MicroZed Errata

Thank you for your interest in the Zynq 7Z010/7Z020 MicroZed board. Although Avnet has made every effort to ensure the highest possible quality, these boards are subject to the limitations described in this errata notification. This document pertains to MicroZed Revision B, C, and F boards (revision D & E MicroZed boards were not produced).

3.6 USB Host Configuration Resistor

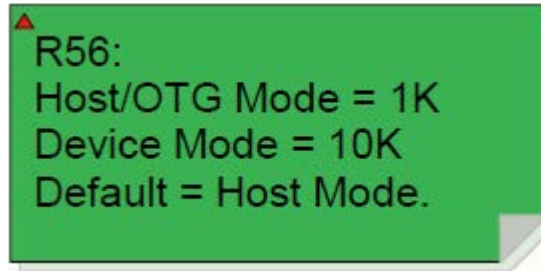
MicroZed uses a MicroChip USB3320 device for the USB Host circuit. On Sheet 5 of the MicroZed schematics, see the following note:

This is incorrect. This resistor is the R_{VBUS} resistor, which according to the USB3320 is specified to be:

Since the default operating mode on MicroZed is Host Mode, R56 should be 10K Ω but it is populated incorrectly as 1K Ω .

Change R56 to 10K Ω .

This issue is corrected on Revision F-06.
